D/DRC Case

Innovista Design District

DESIGN/DEVELOPMENT REVIEW COMMISSION
DESIGN REVIEW DISTRICT
February 13, 2014
EVALUATION SHEET
Case #2 Regular Agenda - Urban

NATURE OF REQUEST: Request for Certificate of Design Approval for new construction of private student dormitories.

MASSING DIAGRAM AT FOUNDATION SQUARE

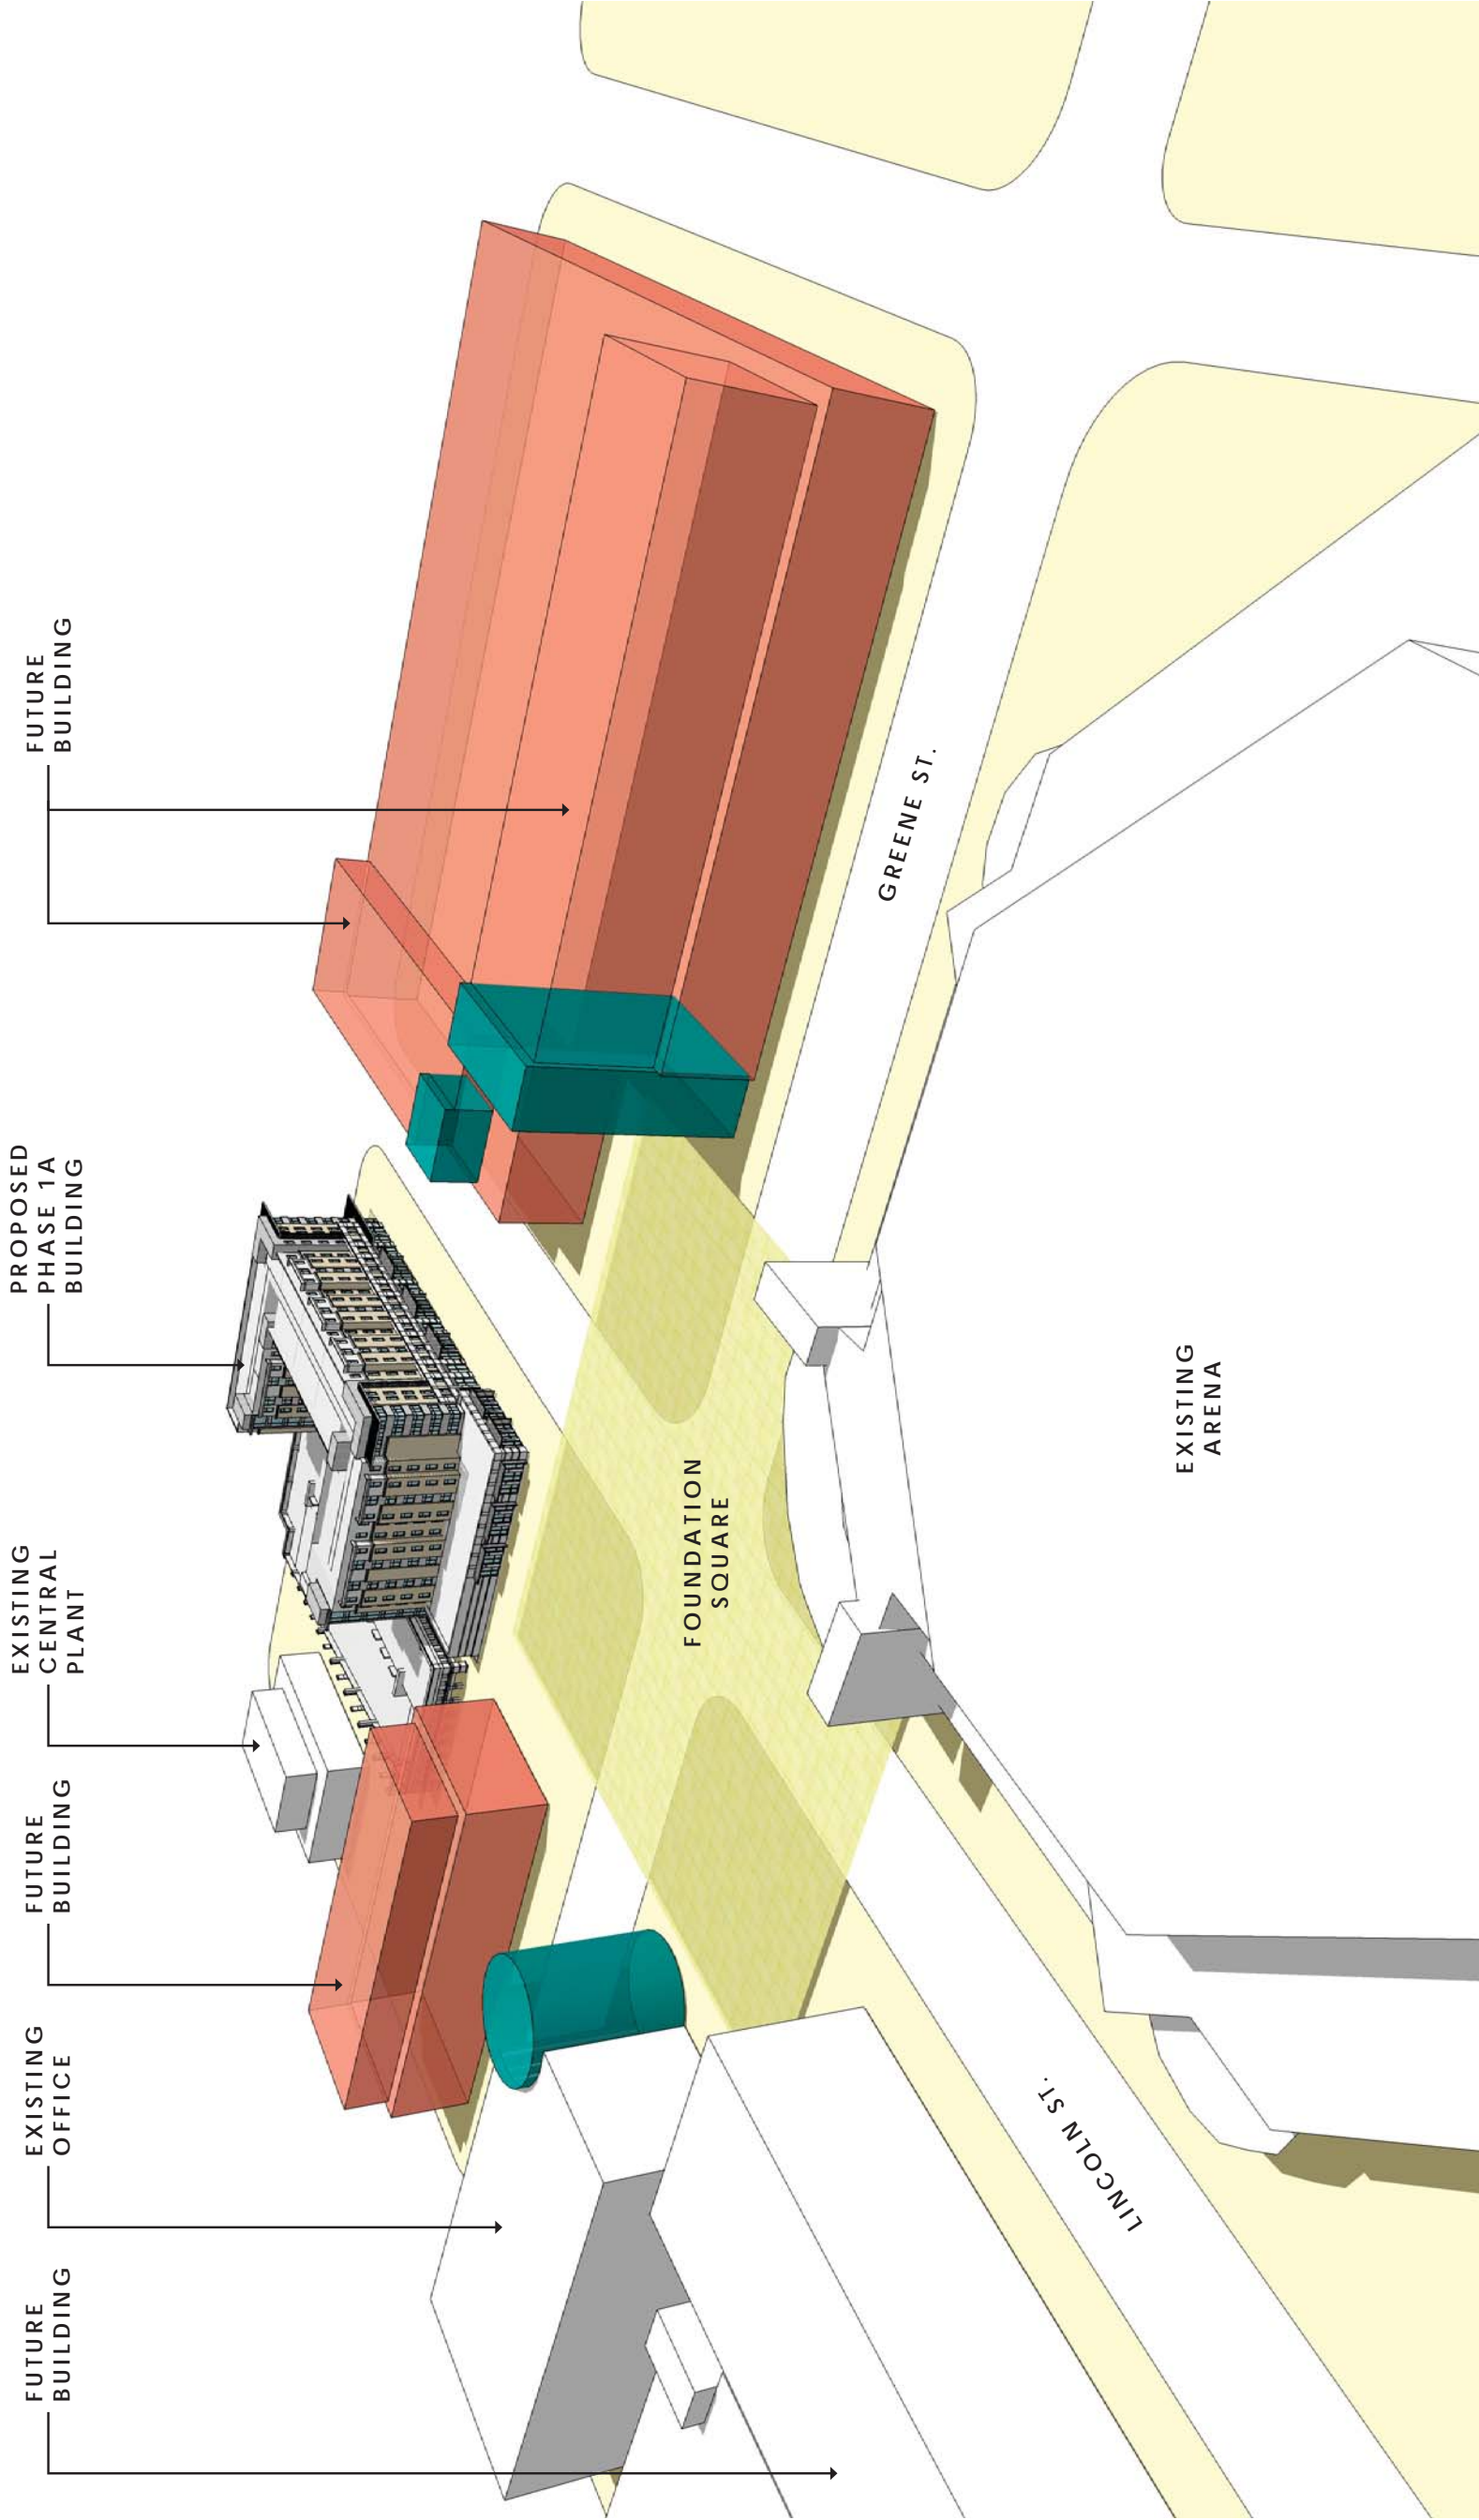
Staff is concerned about the height of the one story mass facing Foundation Square. The Innovista Master plan calls for a plaza within the private property of 35 feet by 35 feet. The height of the buildings to the east and to the south of this plaza is recommended to be 45 feet with a building setback of an additional 8 to 35 feet. The proposal has a plaza that is 135 feet by 125 feet. In addition the setback from the plaza wall to the upper floors is 40 feet and this plaza wall height is approximately 24 feet rather than 45 feet.

Staff has no recommendation as to the plans that have been submitted.

S3 STREET SECTIONS

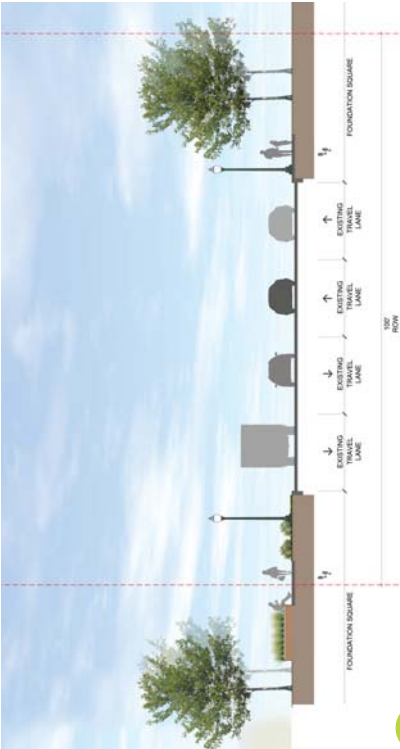
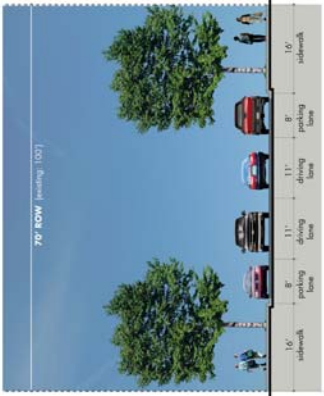
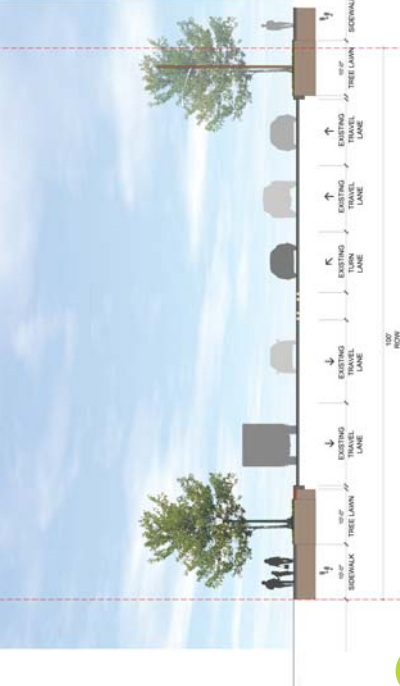
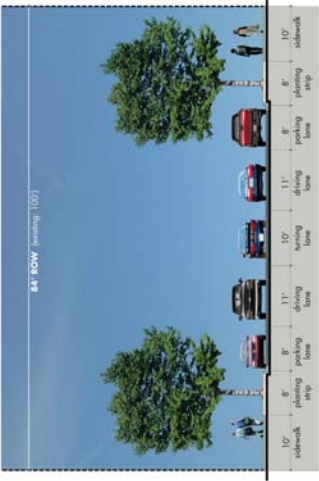
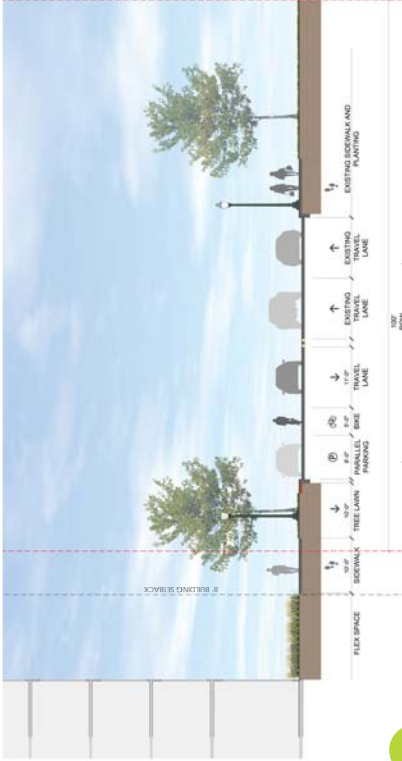
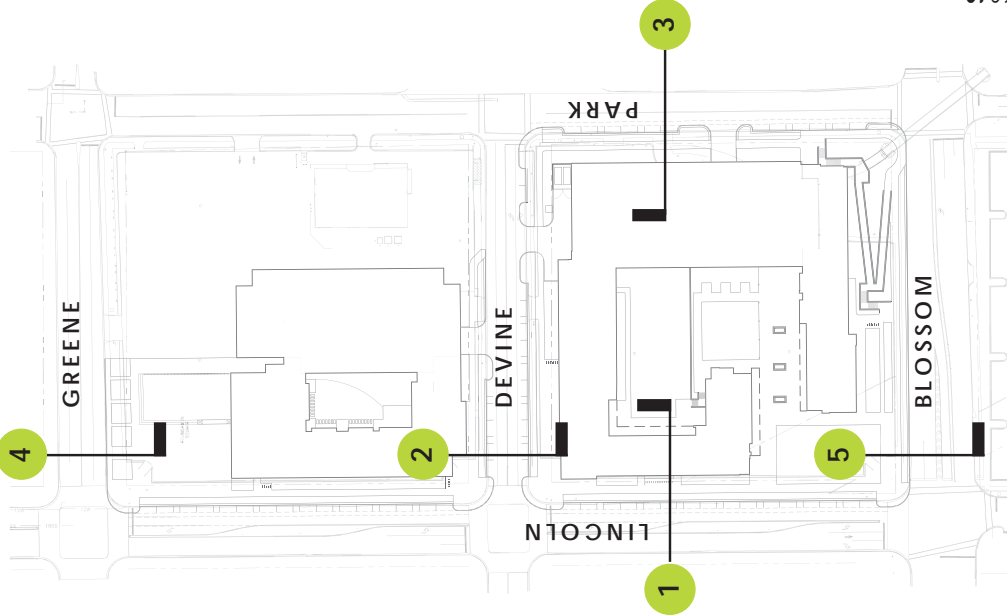
At Lincoln and Blossom Street the Innovista plan recommends a 90' x 90' plaza - the applicant has provided an 80' x 80' plaza. The open space along Blossom Street was to have a width of 45 feet from the right of way line. The proposal has a width of 40-50 at various points.

Staff recommends that details for open space and founders square be deferred to staff.
